### **Amendments to the Drawings**

## **REMARKS**

Figure 3

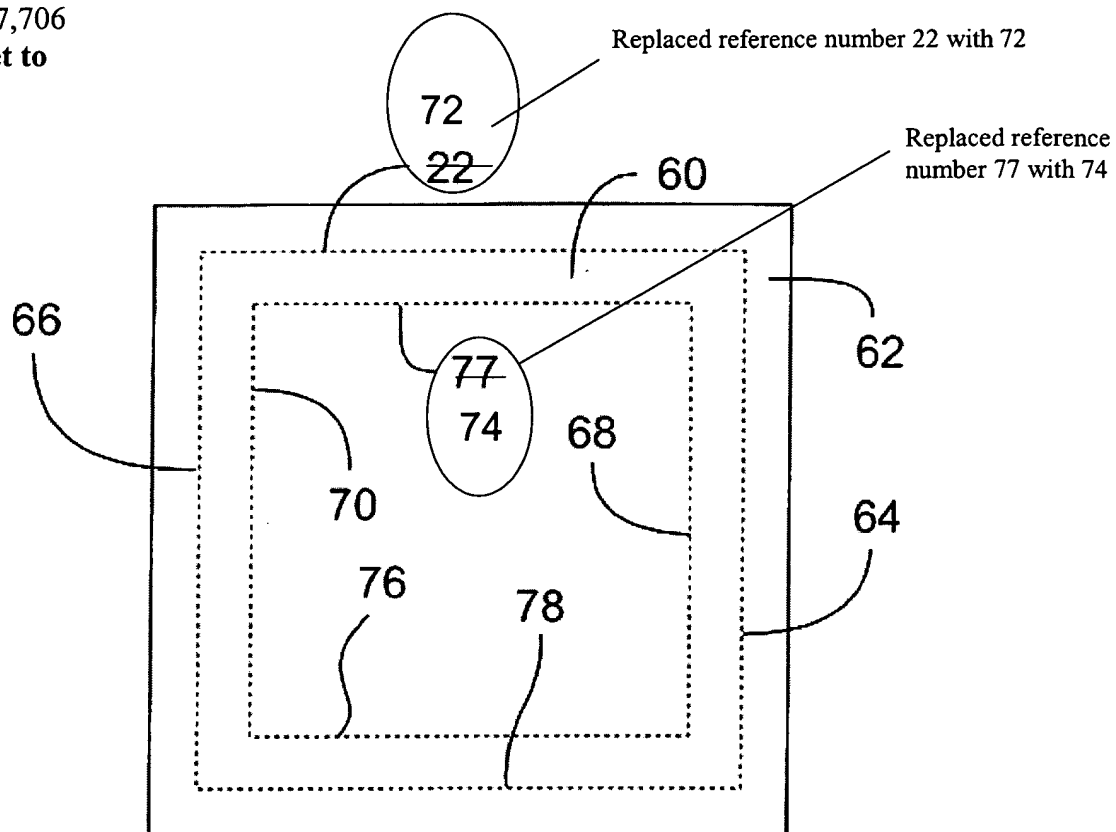
In amended Figure 3, the reference number 22 has been replaced with corrected reference numeral 72 and reference numeral 77 has been replaced with reference numeral 74.

Figure 4

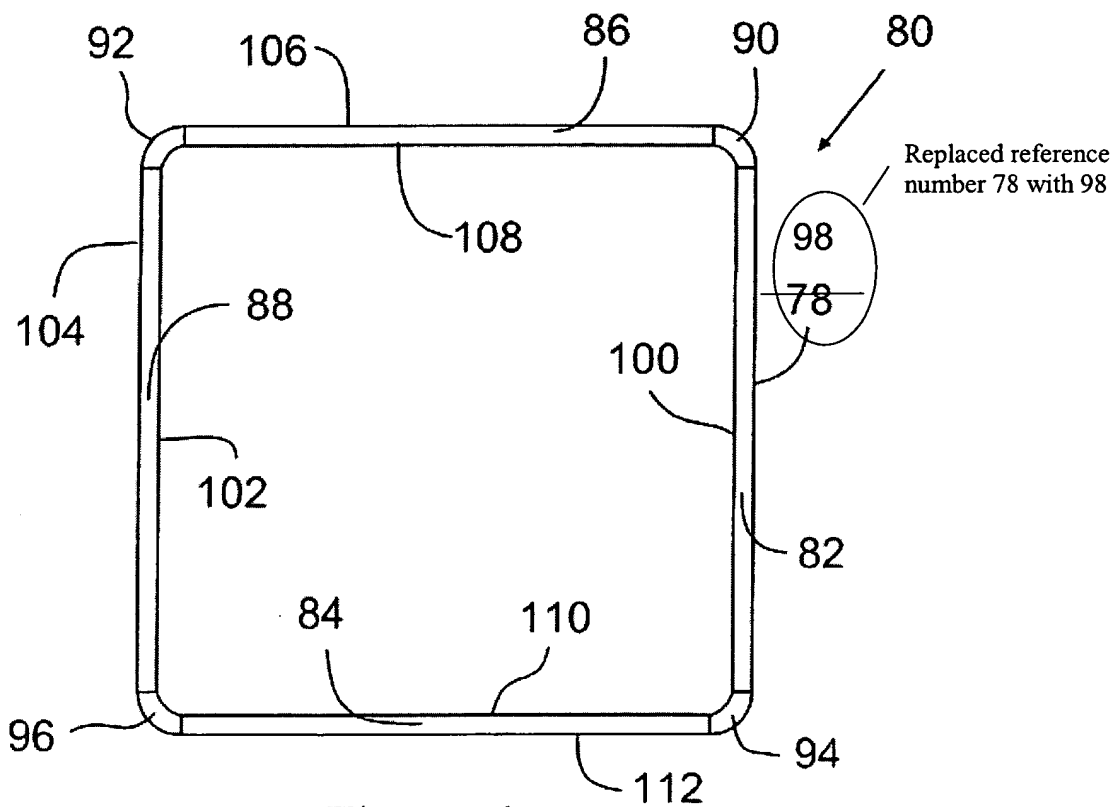
In amended Figure 4, the reference number 78 has been replaced with corrected reference numeral 98.
